Planning Commission Staff Report

File # 9S22/SUB-000248-2022

**Public Hearing and Consideration of a Preliminary
Subdivision Plat for 23.95 Acres of Property at 4202 South
Riverboat Road, Taylorsville, Utah.**

Exhibit J: City Review Comments – July 15, 2022

RIVERBOAT ROAD SUBDIVISION
4202 SOUTH RIVERBOAT ROAD
LOCATED IN THE SOUTHEAST QUARTER OF SECTION 35,
TOWNSHIP 1 SOUTH, RANGE 1 WEST, & THE NORTHEAST
QUARTER OF SECTION 2, TOWNSHIP 2 SOUTH, RANGE 1 WEST,
SALT LAKE BASE AND MERIDIAN
TAYLORSVILLE CITY, SALT LAKE COUNTY, UTAH

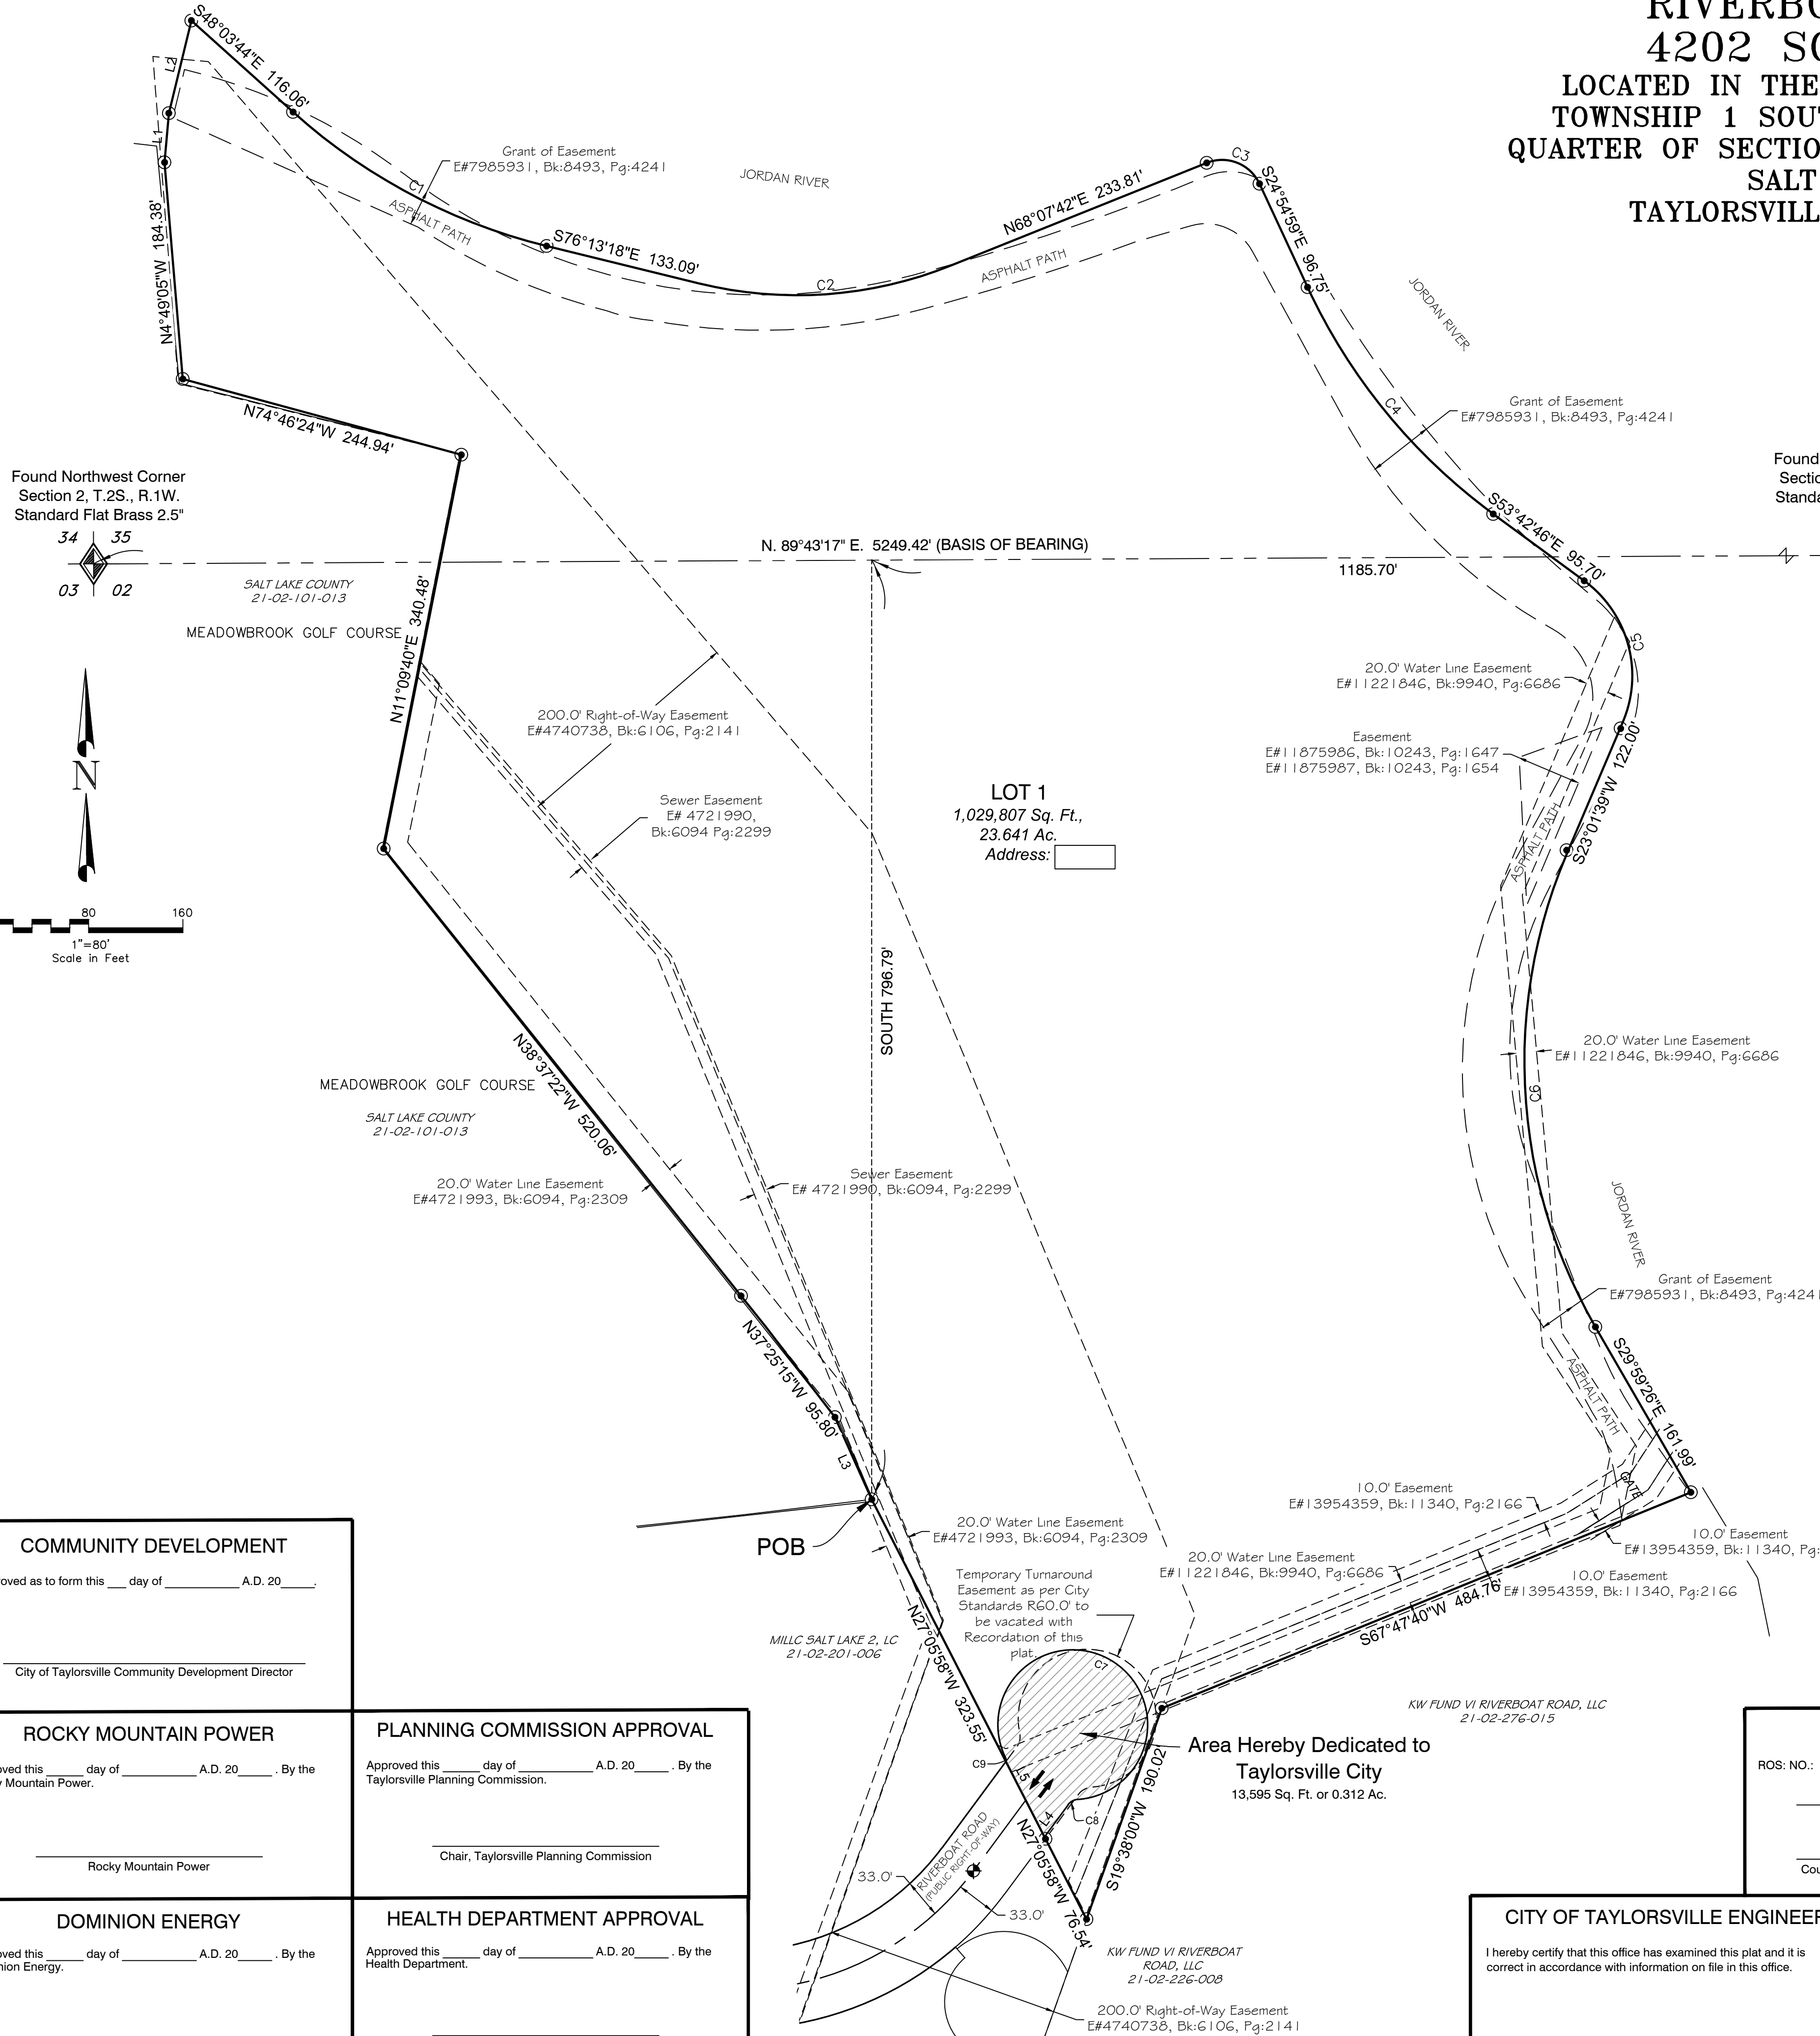
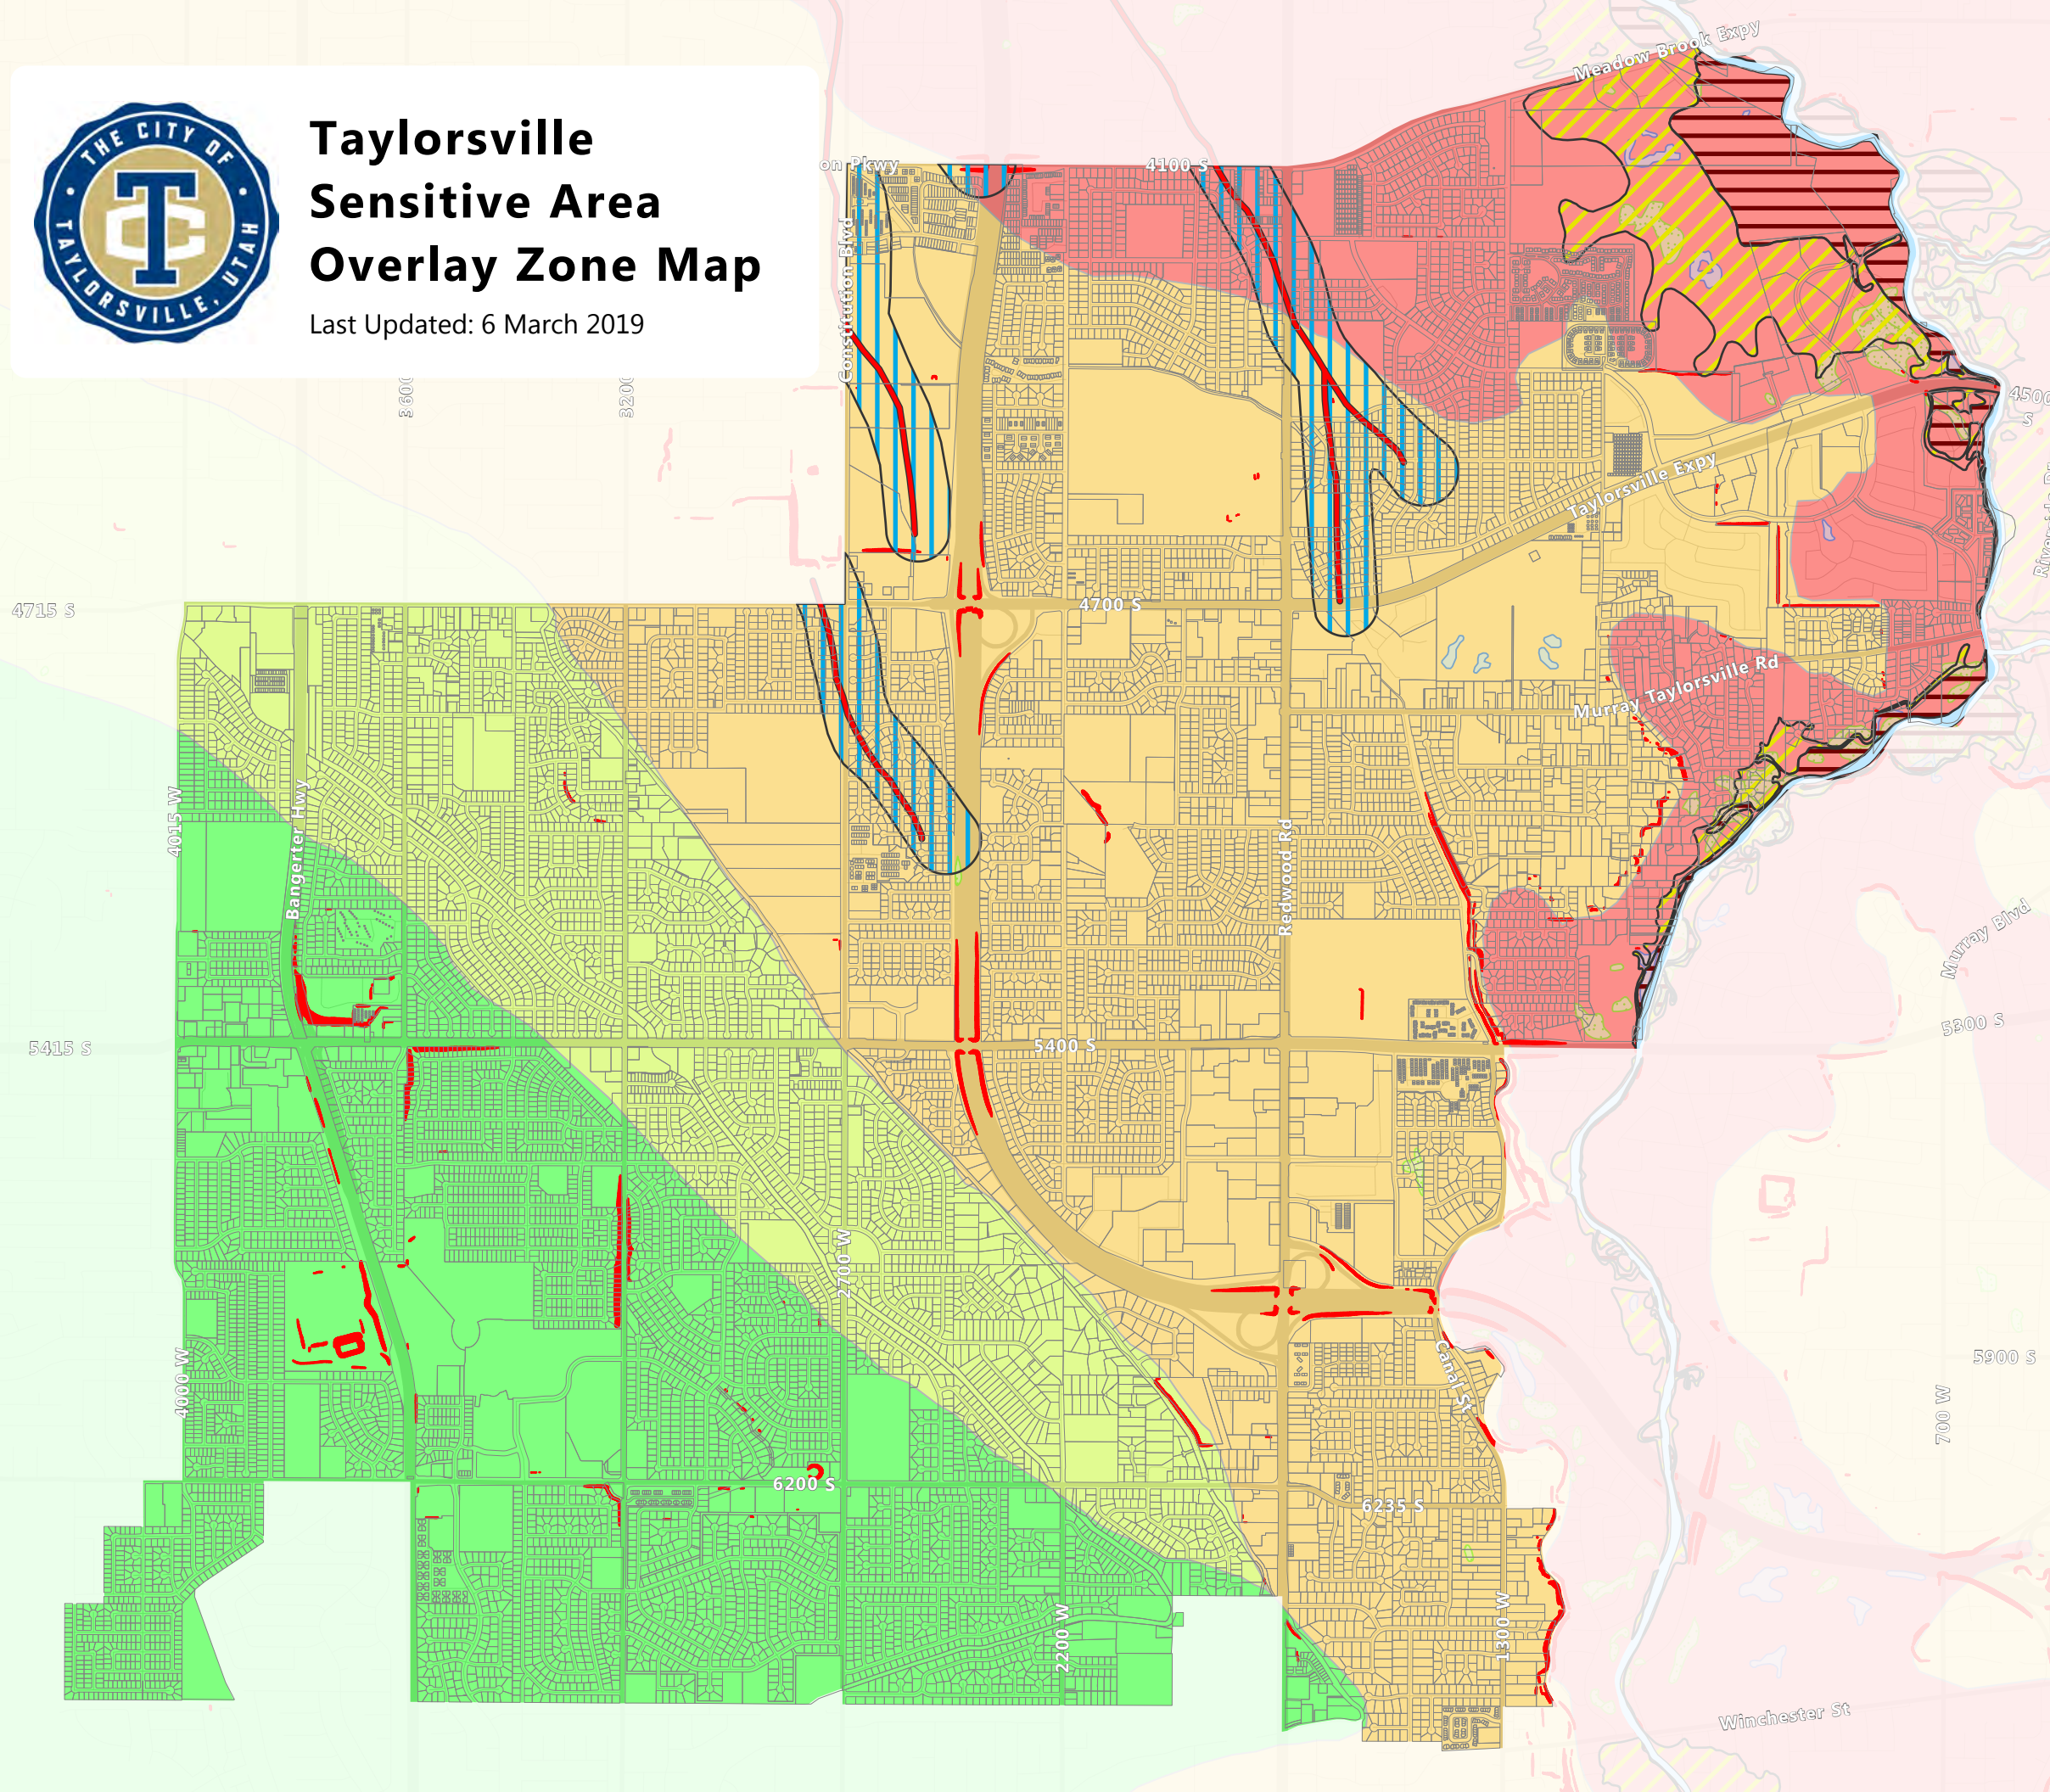
1. **DRAFT PLAT:** Remove address "4202 South Riverboat Road" from plat title.
2. **DRAFT PLAT:** Remove "asphalt path" notations.
3. **DRAFT PLAT:** Add easement line types to legend.

6. **DRAFT PLAT:** Correct curve for "C9" to be tangent and also consistent with "C8."
7. **DRAFT PLAT:** Update signature note for Taylorsville-Bennion Improvement District.
